**AGENDA
FARRAGUT MUNICIPAL PLANNING COMMISSION**

**February 21, 2019
7:00 p.m. Farragut Town Hall**

Re: Staff comments on site plan for Ivey Farms Preliminary Plat

Designed By:	ENR	Checked By:	ENR	Date:	12/13/18	Sheet Number	CP-R1
BROOKMERE FARRAGUT, TN CONCEPT REVISION

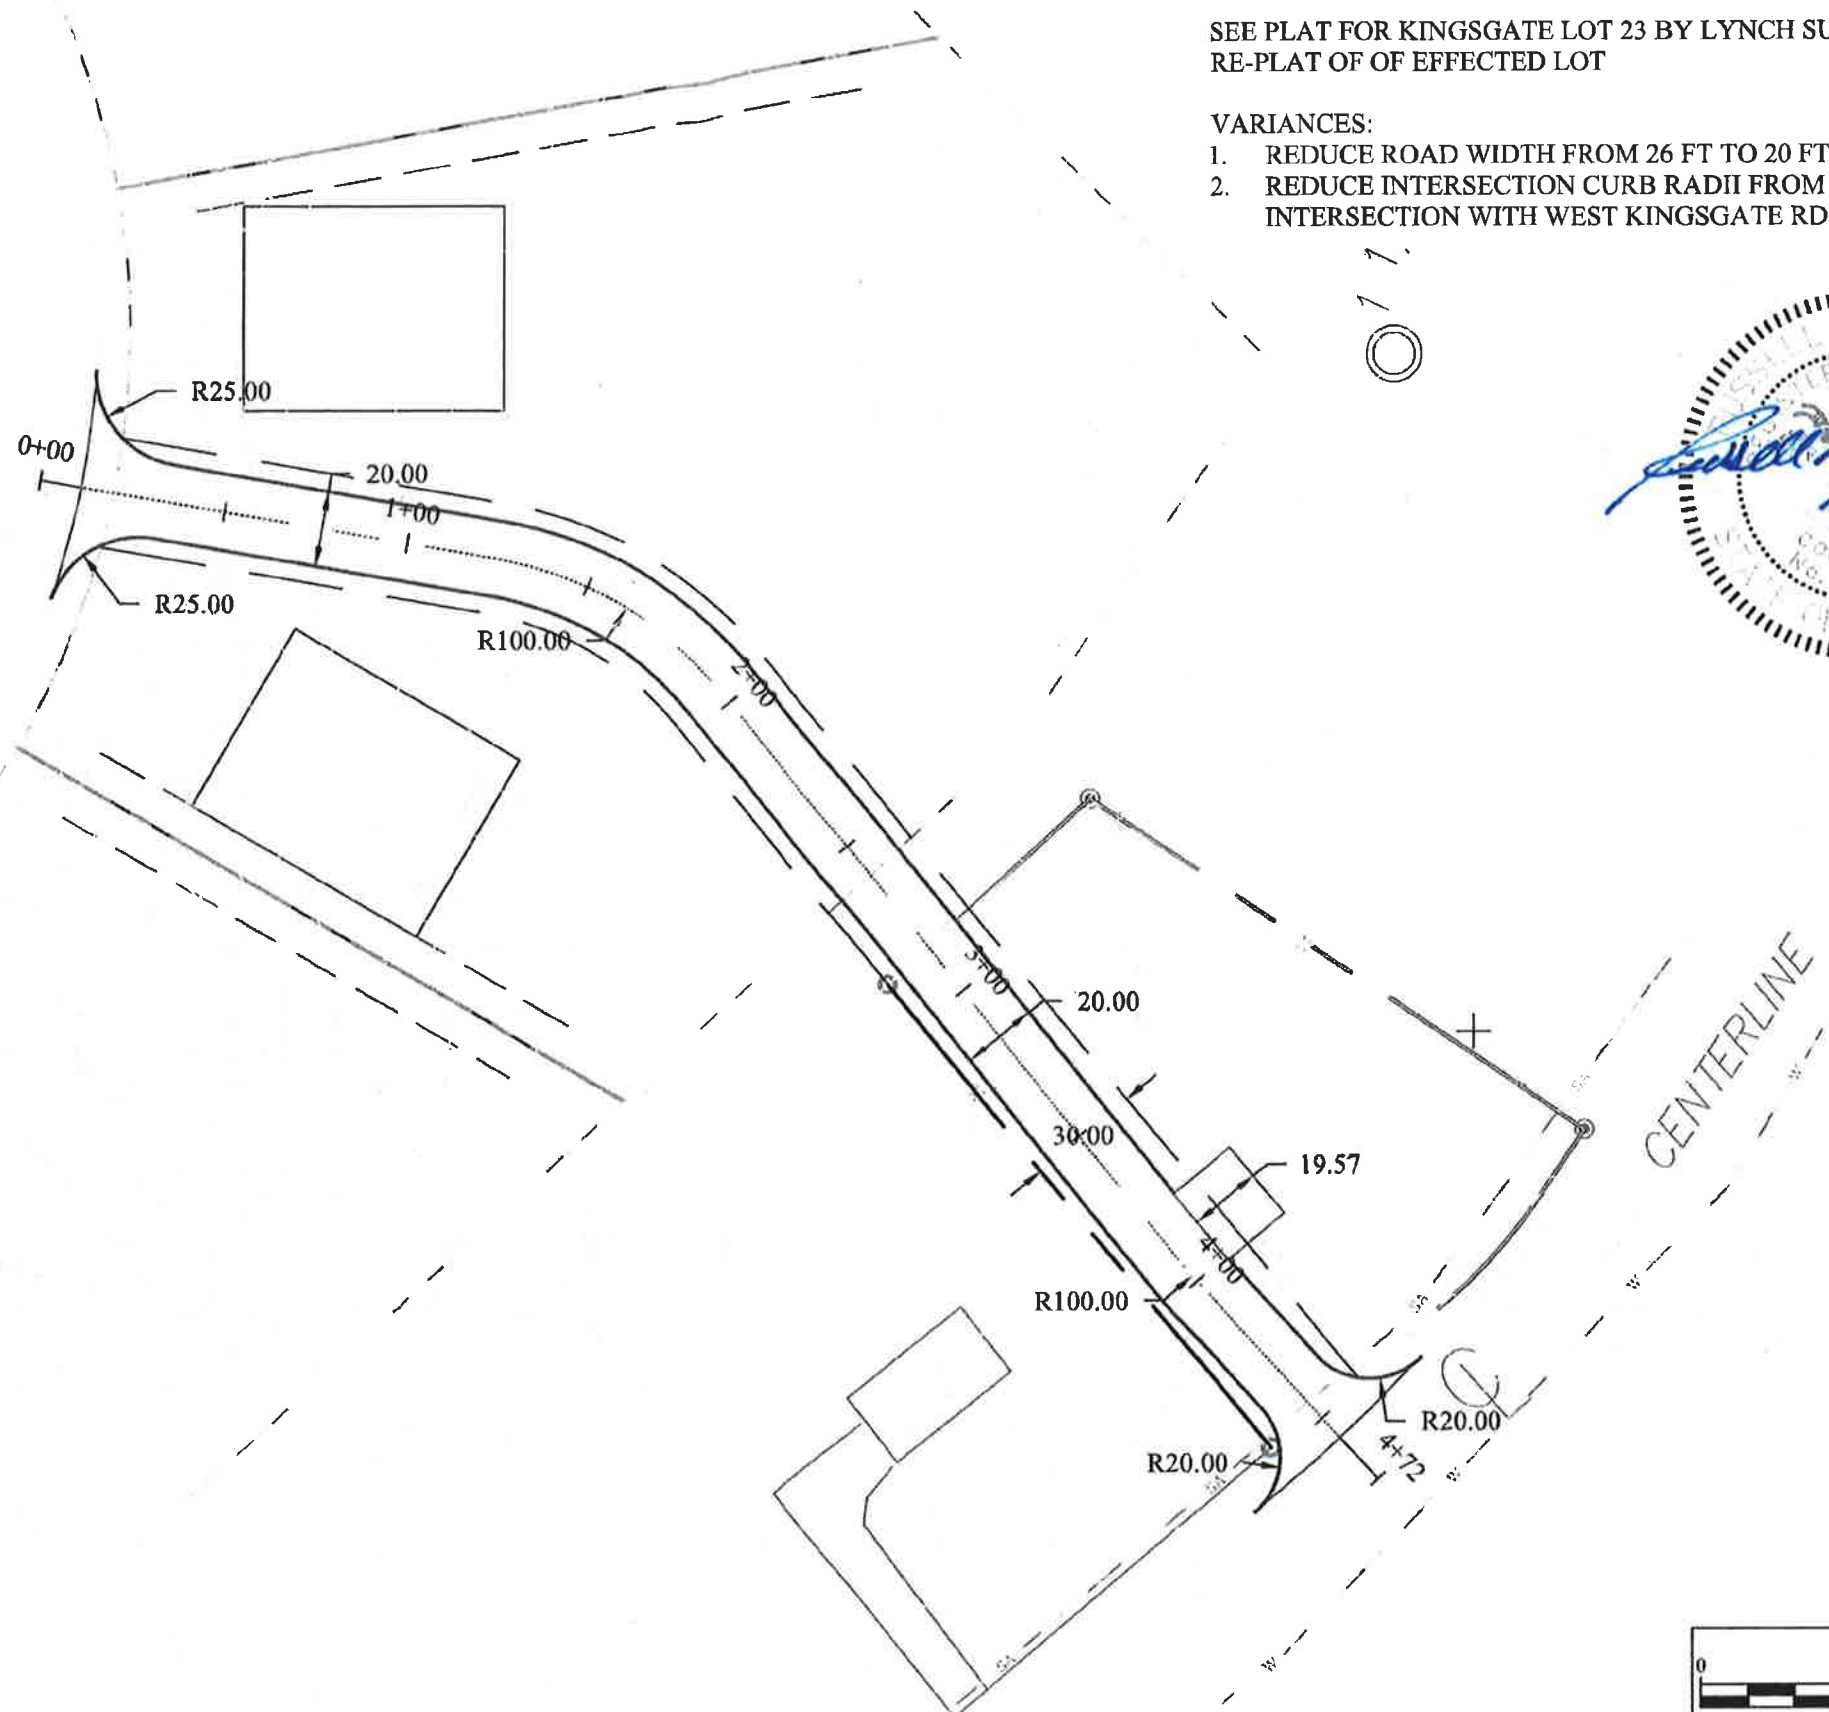
REVISE CONNECTION TO KINGSGATE FROM 20' EASEMENT WITH FIRE APPARATUS ACCESS TO 30' PUBLIC ACCESS AND UTILITY EASEMENT WITH 20 FOOT WIDE CURBED STREET.

Site Layout Plan - North

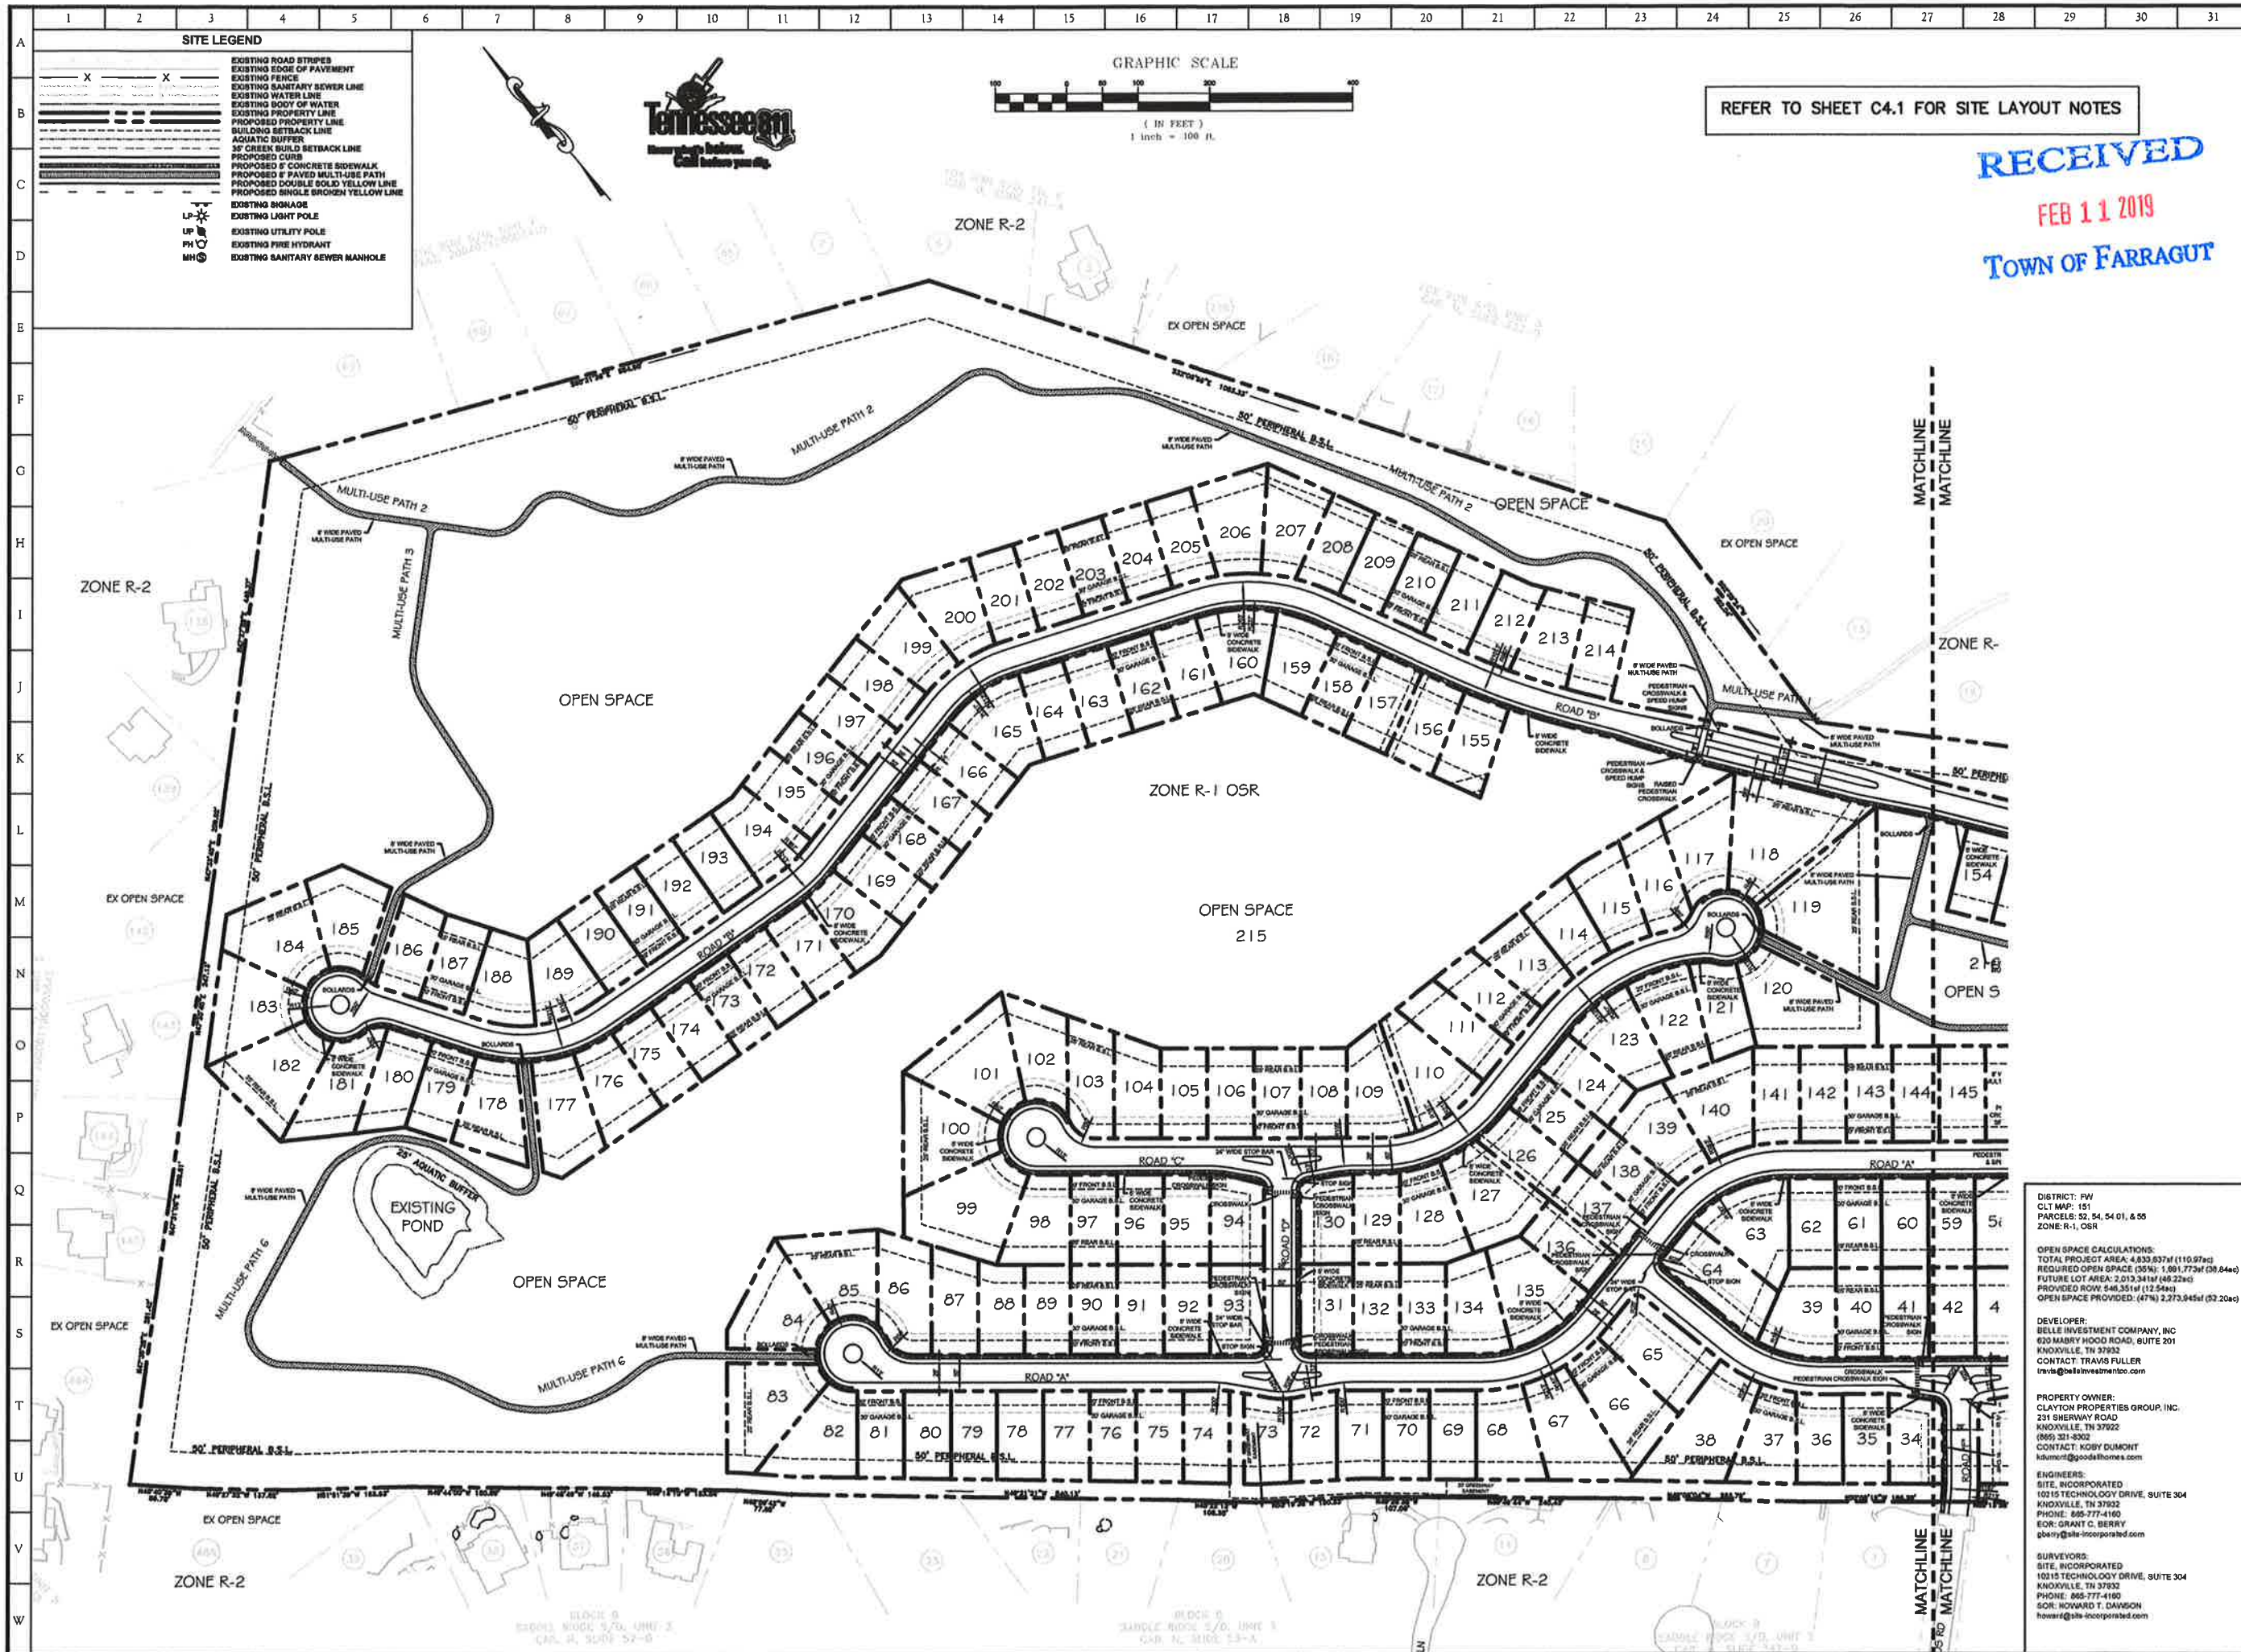
Response: A second mail facility has been added to Road E.
- 5) Please address the relationship between the sidewalk termination shown on sheet C.4.2 at Union Road, the proposed multi-use trail along Union Road (by others), and pedestrian connectivity along the proposed Ivey Farm Road and the Swan Farm development. Specifically, how and where will pedestrians walking from the subdivision cross the various roadways involved to access the residential and commercial developments proposed for the Swan Farm;

Response: Access will be provided by the use of crosswalks and sidewalks along and across Union Road.
- 6) Are there any open space lots in adjoining subdivisions to tie into for habitat corridor purposes?

Storm Water Pollution Prevention Plan - Phasing

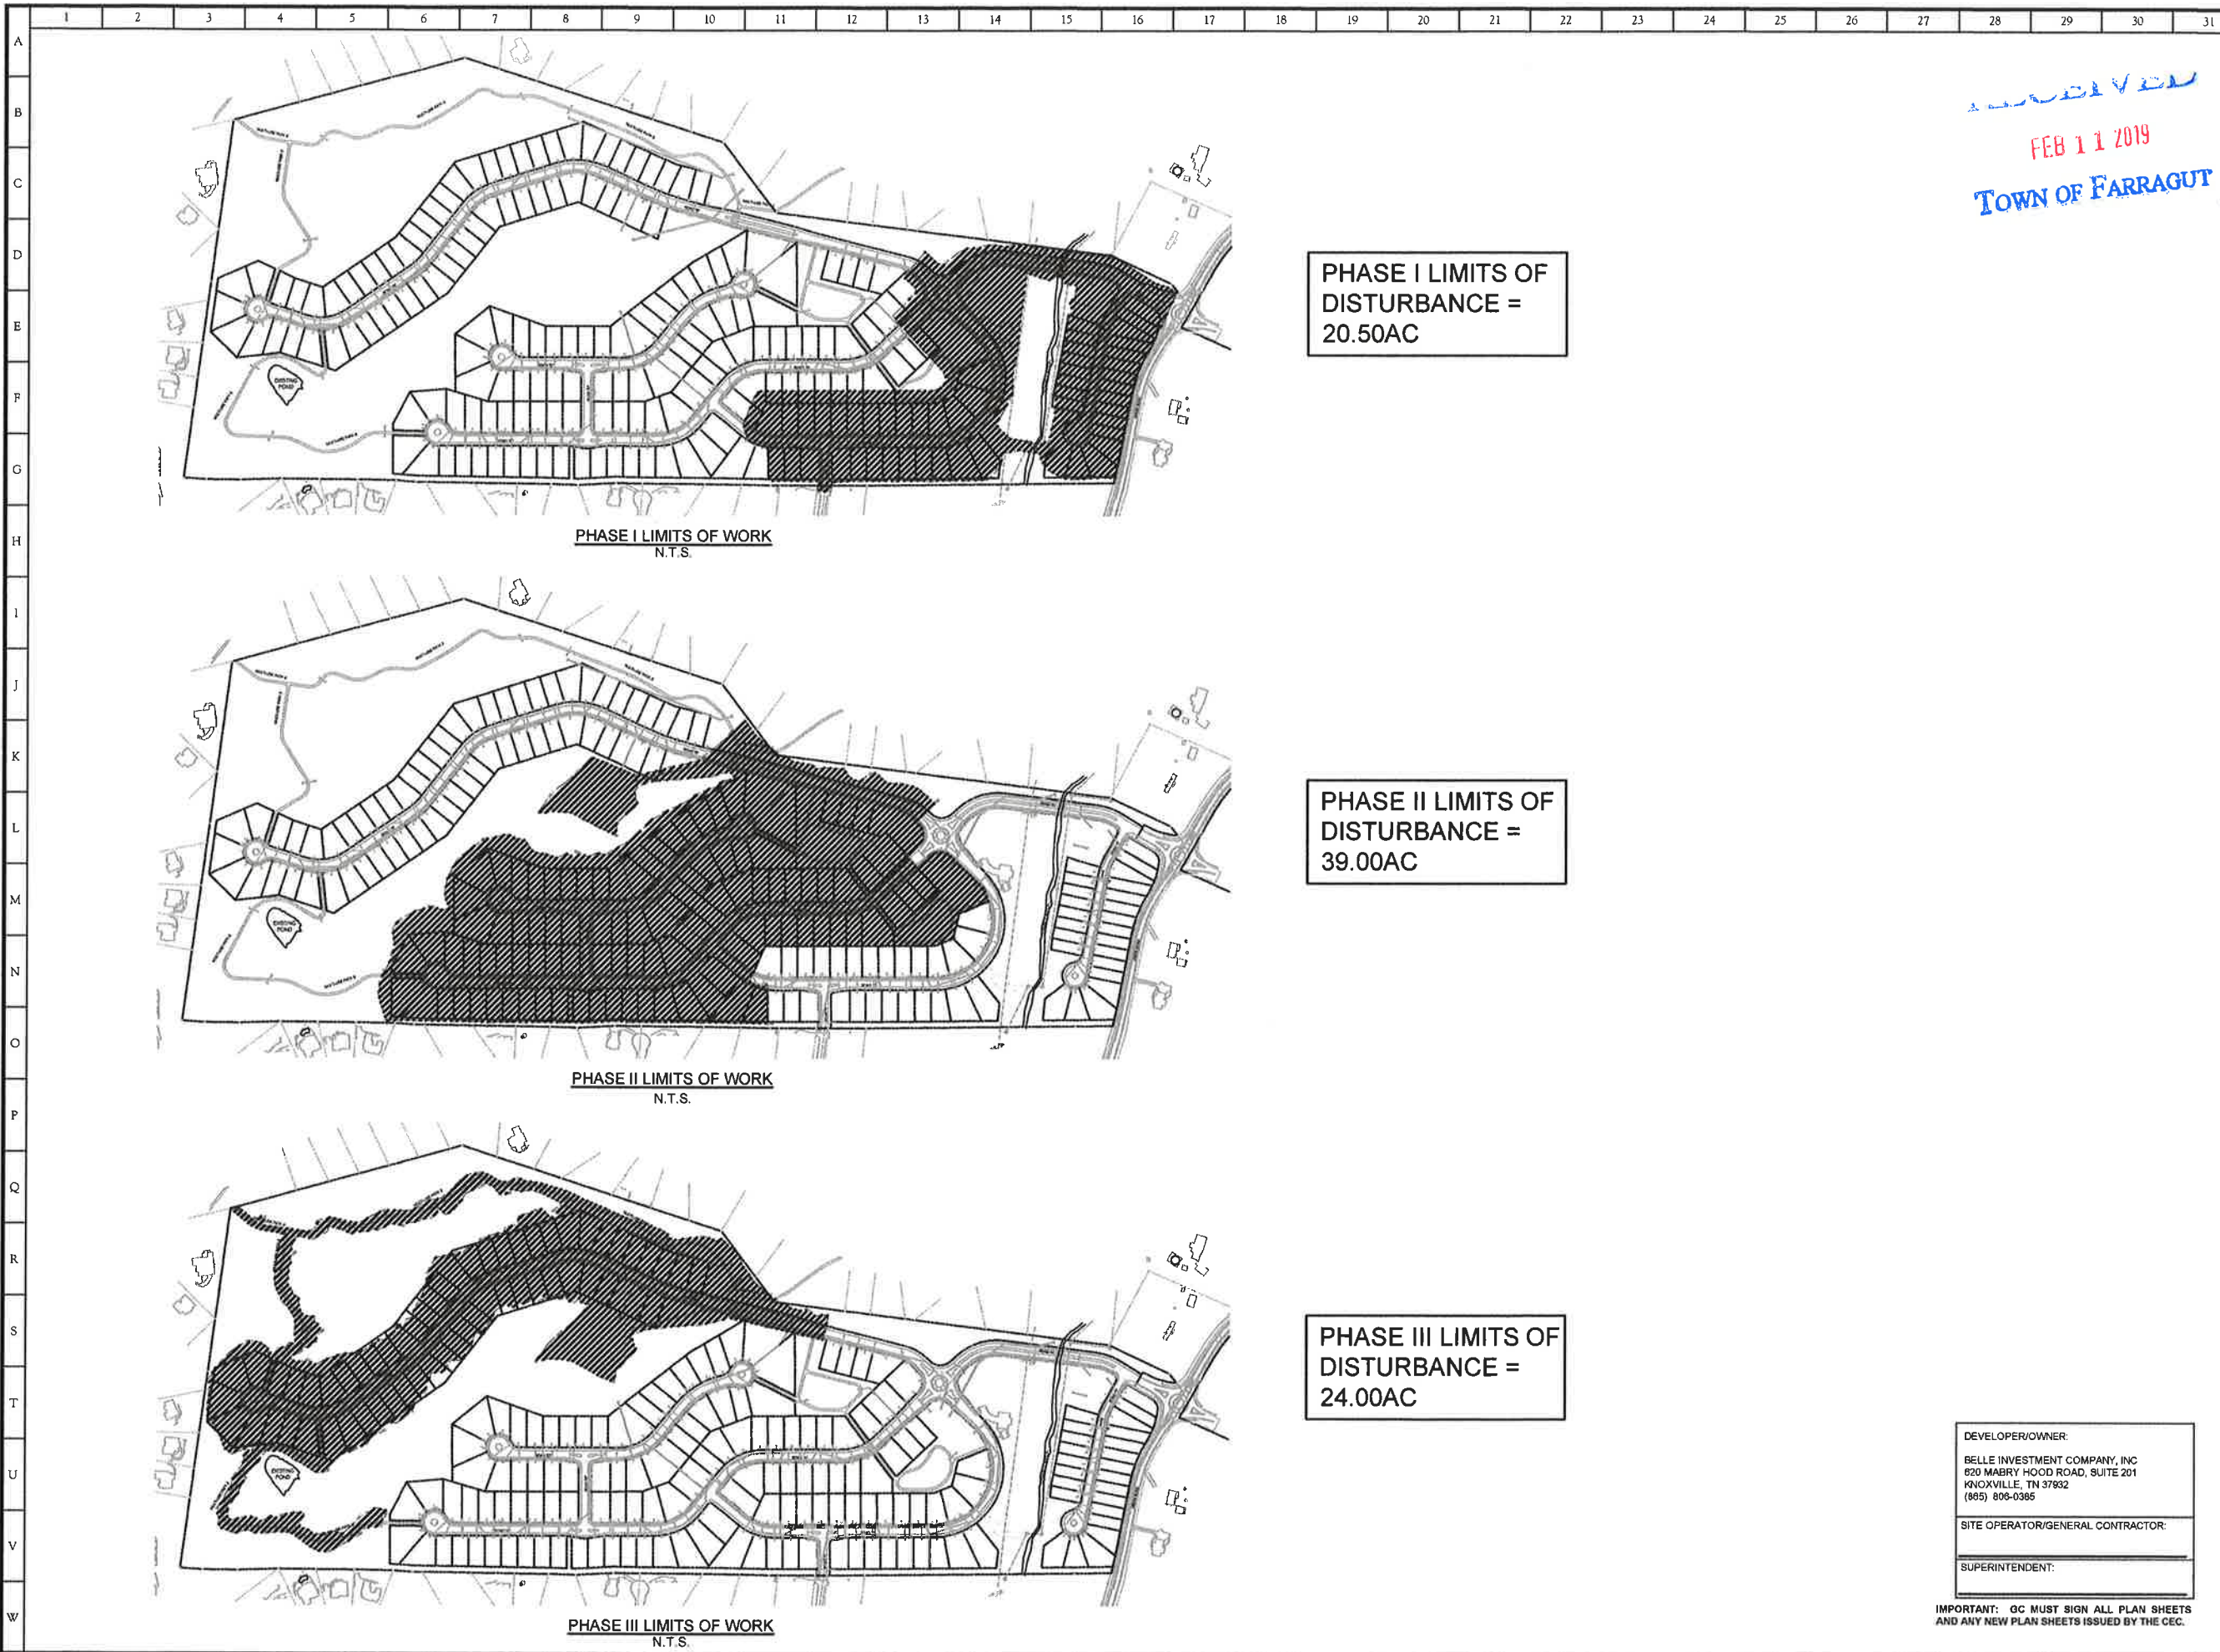
- 27) SWPPP sheets are difficult to read at small scale. Recommend providing sheets for each section as was done for grading.

Response: Smaller scale drawing will be provided.
